Sea Link

Document 9.65: Draft Statement of Common Ground Between National Grid Electricity Transmission and the National Trust.

Planning Inspectorate Reference: EN020026

Version: **AB**

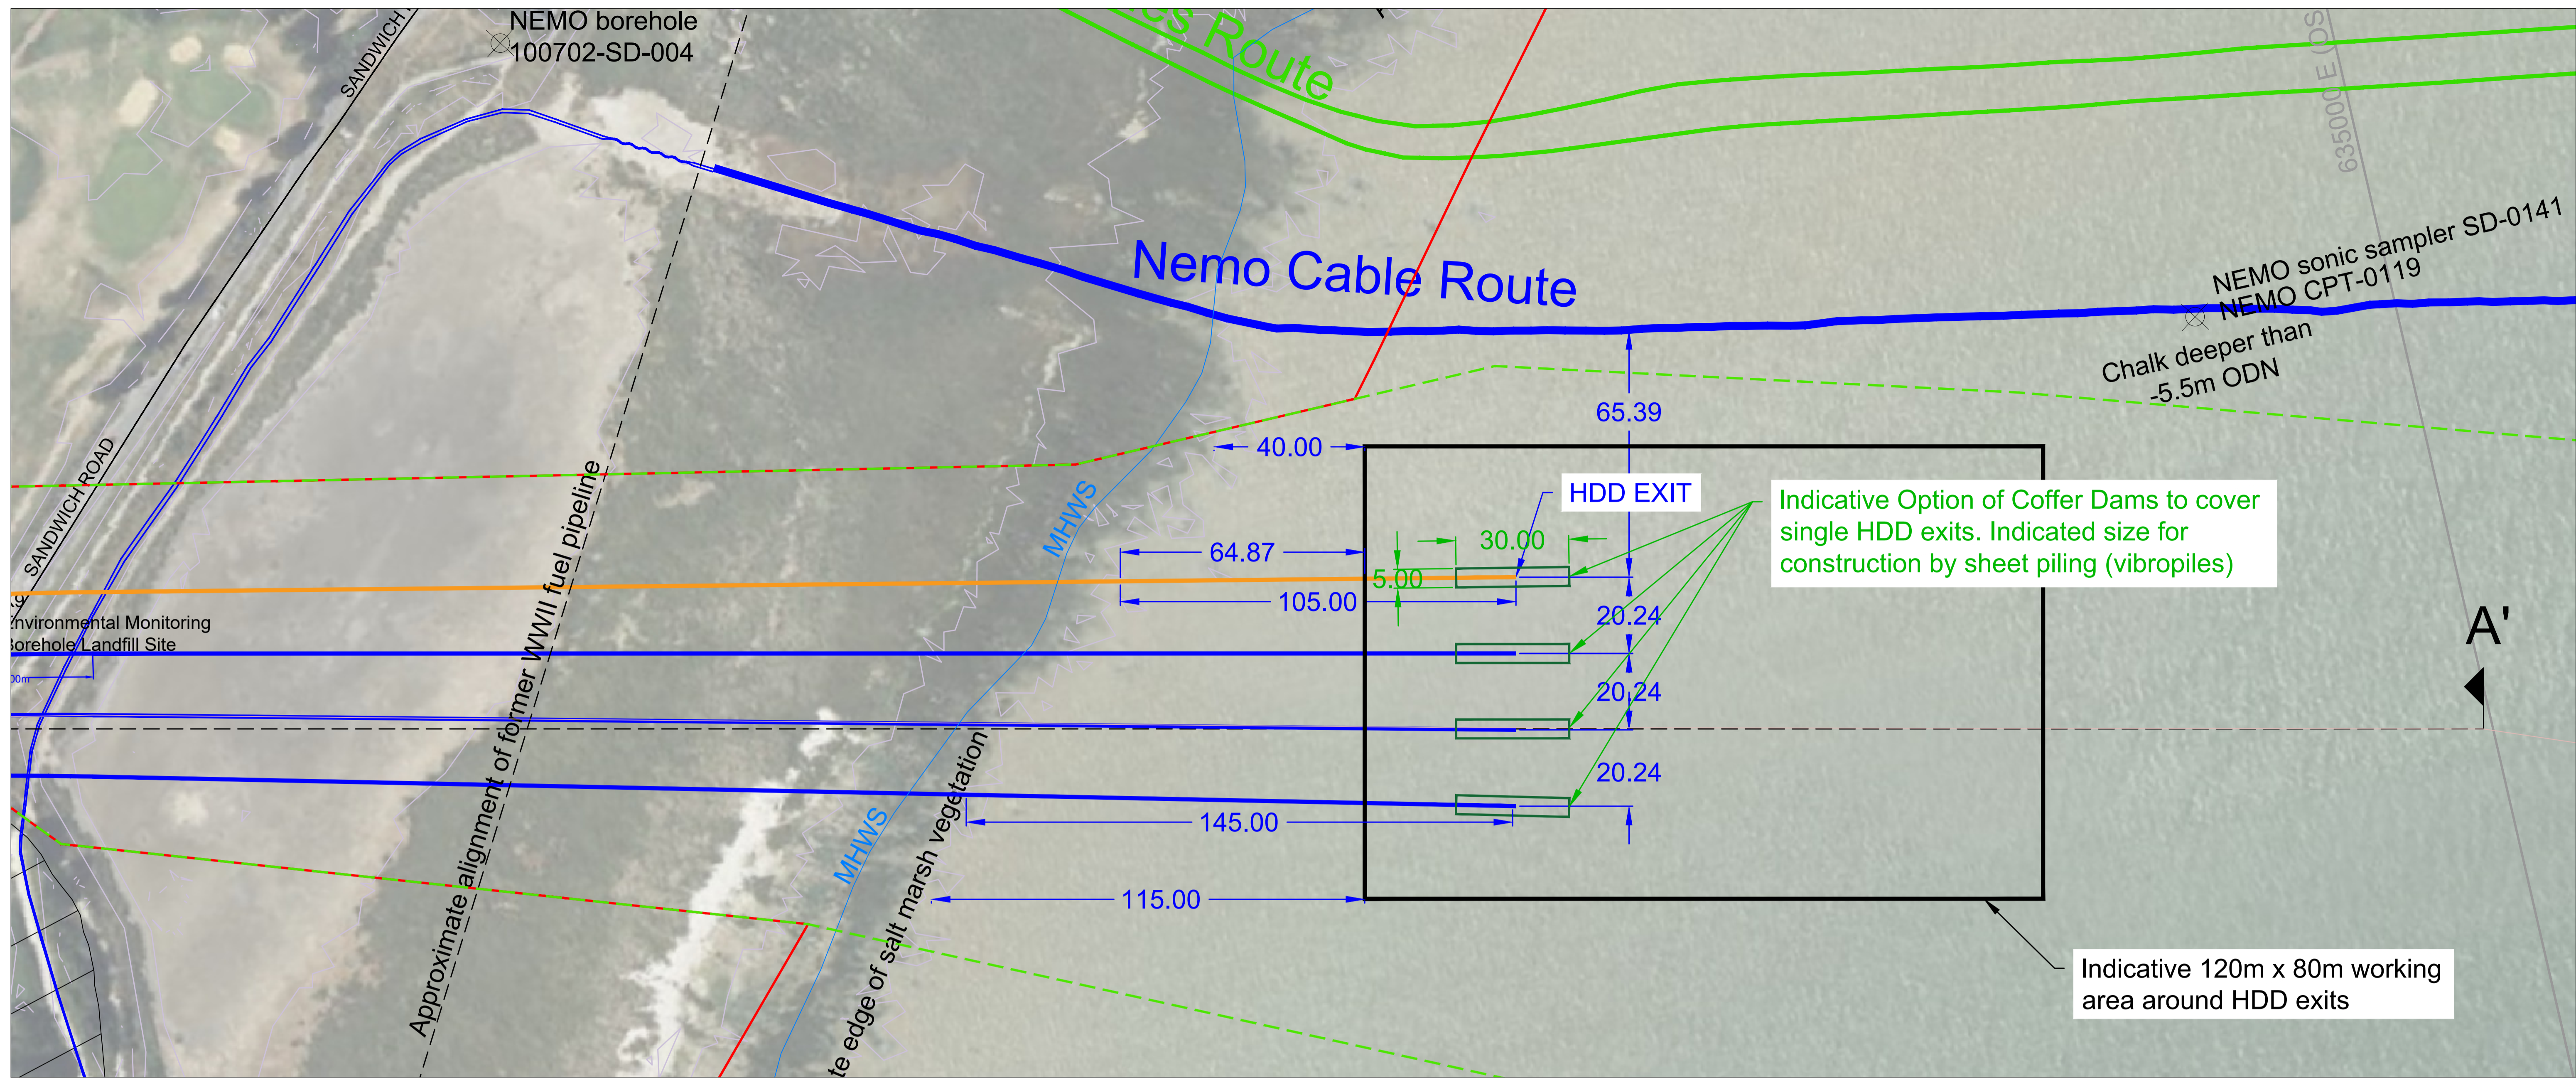
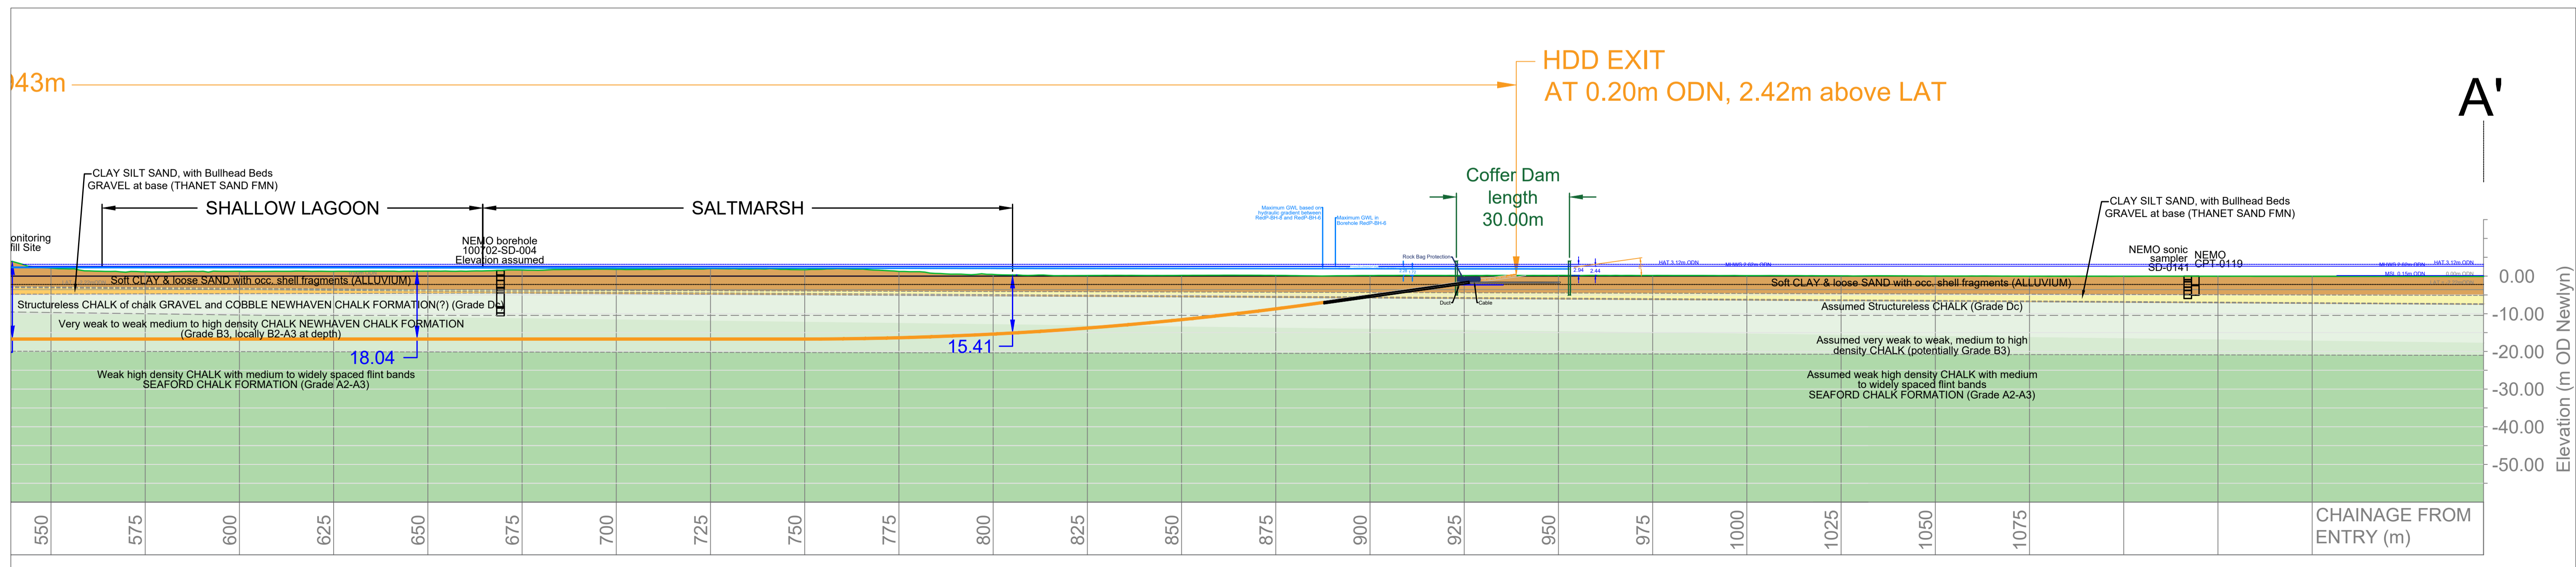
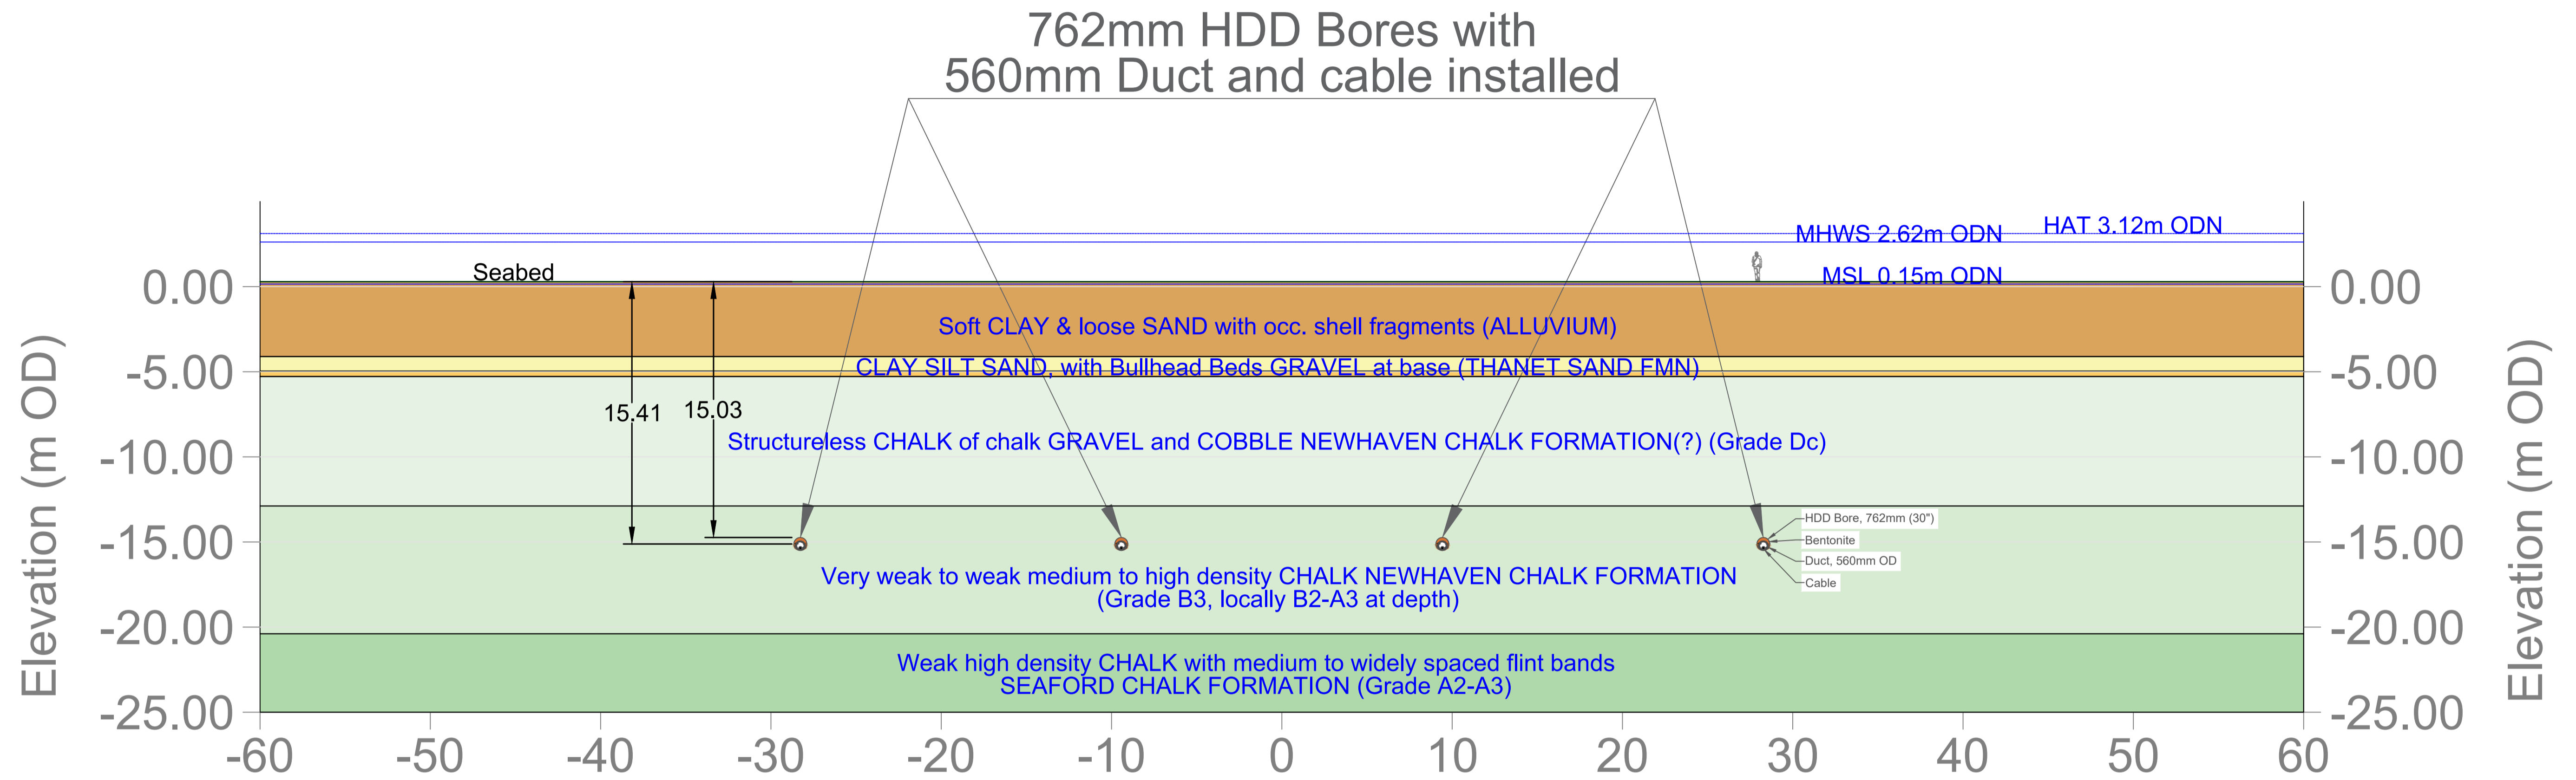
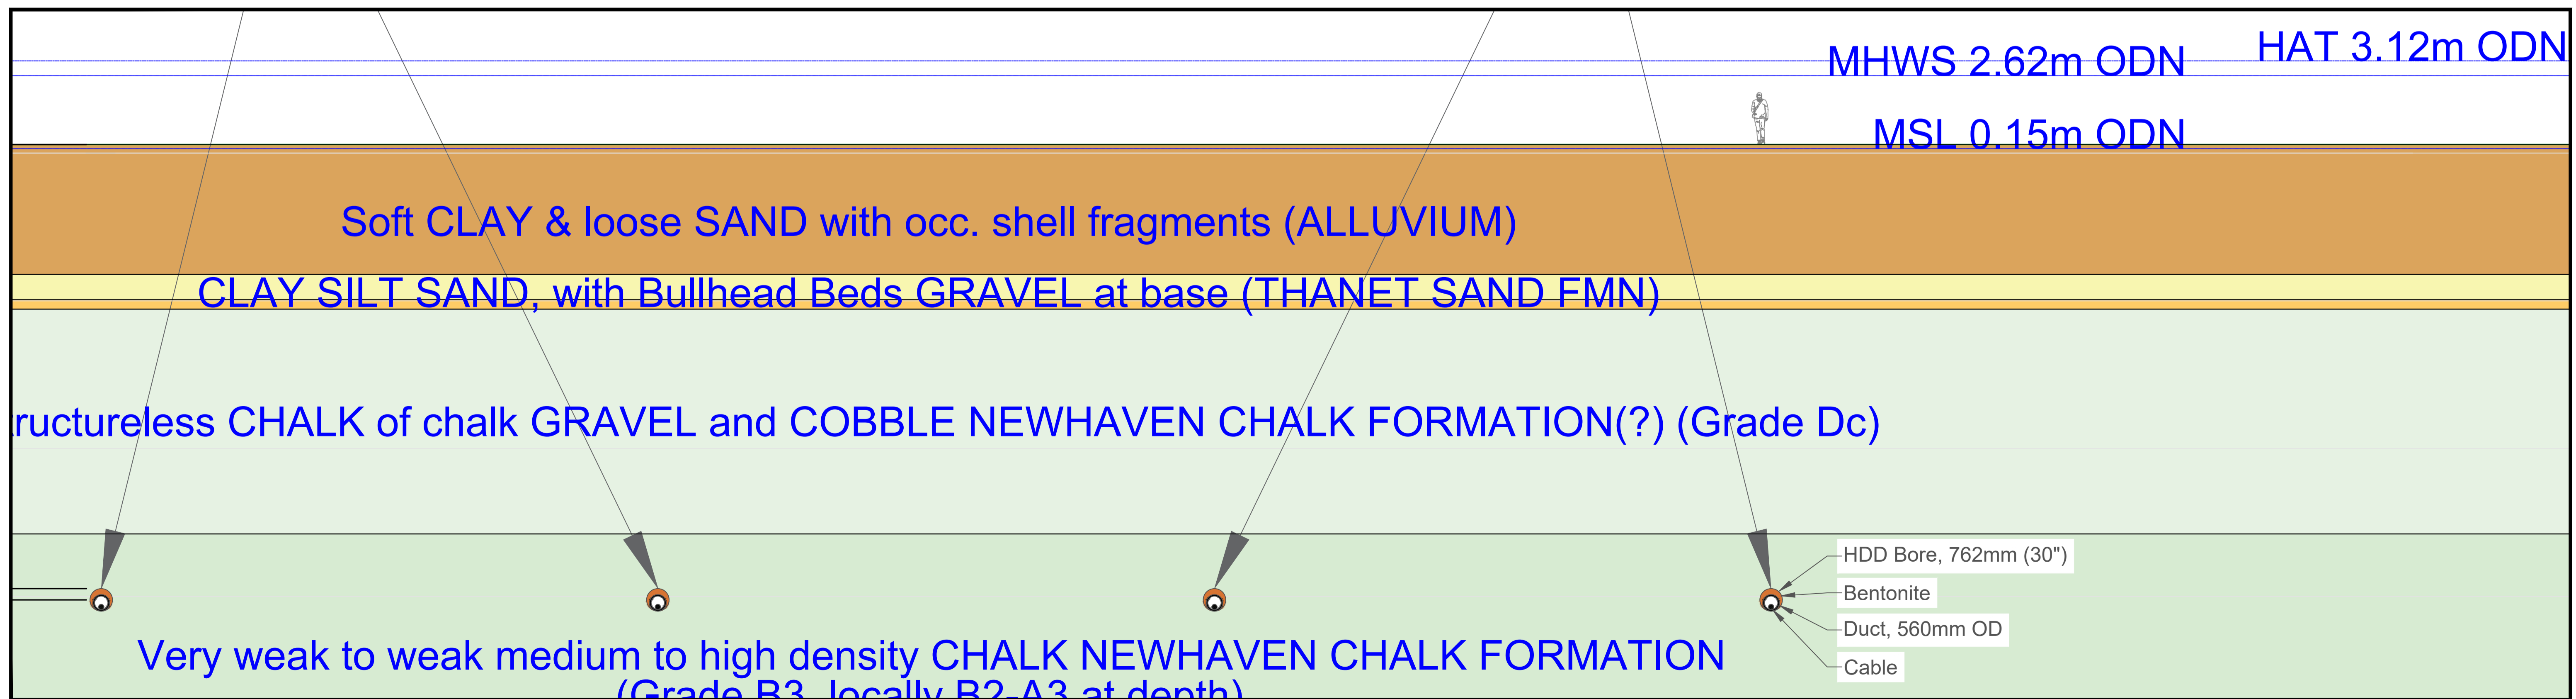
Ref	Relevant Application Documents	Description of Matter	Consultee's Current Position	The Applicant Current Position	Status
Chapter 2		Horizontal Direct Drilling (HDD) Impacts on Ecological designations on National Trust Land	<p>The National Trust does not object to the principle of the proposed offshore high voltage direct current link between Suffolk and Kent with onshore converter stations and connections back to the national electricity transmission system.</p> <p>We would support the developer's use of Horizontal Directional Drilling (HDD) construction methods at Pegwell Bay and would expect to see a firm commitment to undertake this form of engineering if this proves to be less detrimental than other alternatives. The entry point for the HDD is 470m west of the SAC/SPA/SSSI and Trust land. It is proposed to drill at 15-18m depth under the saltmarsh, and the exit point will be to the east of the saltmarsh in intertidal mudflat (Figure 6.4.4.2.4 Habitats present at, and location of, trenchless solution entry/exit points). However, the method statements do not rule out the need for trench installation if HDD proves to be difficult/impossible to use. If trenchless techniques are used, the Trust would have concerns due to the potential of the cumulative impacts on the Nature Reserve arising due to the possibility of the proliferation of cables installed previously for the Nemo link. Consequently, the Trust would want assurances that there will be nothing above ground on our land.</p> <p><u>The Trust welcomes the Applicant's confirmation. The Trust seeks in addition that the Applicant completes an HDD Management Plan after first consulting with the Trust and other relevant stakeholders.</u></p>	<p>The current draft DCO prohibits cable installation in Pegwell Bay using techniques that are not trenchless- <a href="#">to cross the sensitive saltmarsh</a>. If other than a trenchless technique were proposed at this location, any proposals for alternative methods would require a formal amendment to the DCO and would need to be supported by an additional environmental assessment.</p> <p>However, as outlined in <b>Application Document 7.3 Design Development Report – Appendix A Landfall HDD Feasibility Technical Note [APP-321]</b>, ground investigations have confirmed suitable drilling conditions for HDD. The report states that initial hydrofracture modelling, using ground strength parameters from the ground investigations, shows a 2.8 factor of safety against frac out. This means that the drilling fluid pressure would need to be 2.8 times the pressure required to drill through the formation, to cause a surface frac out in the SSSI. Therefore, there is a very low risk of frac out.</p> <p><u>The Applicant can confirm that the HDD contractor will produce a detailed, drilling fluid management plan to be approved by the MMO in consultation with relevant stakeholders including Natural England, that includes drilling fluid breakout mitigation measures, where HDD is proposed. This is currently secured within the Deemed Marine Licence through <b>Application Document 9.92 (A) Outline Cable Specification and Installation Plan [REP4-090]</b> submitted at Deadline 4, <b>Application Document 7.5.2 (B) Outline Offshore Construction Environmental Management Plan [REP4-223]</b>, and also within <b>Application Document 9.84 (B) Register of Environmental Actions and Commitments [REP4-234]</b> under <b>B59</b>.</u></p> <p><u>In addition to the above, a HDD Landfall Method Statement will be developed following detailed design which is currently secured within the Deemed Marine Licence through <b>Application Document 7.5.2 (A) Outline Offshore Construction Environmental Management Plan [APP-339]</b>. The National Trust will be consulted on this document.</u></p> <p><u>A list of relevant securing mechanisms for the Proposed Project is provided in Appendix A. In addition to this, a cross sectional image</u></p>	Under discussion
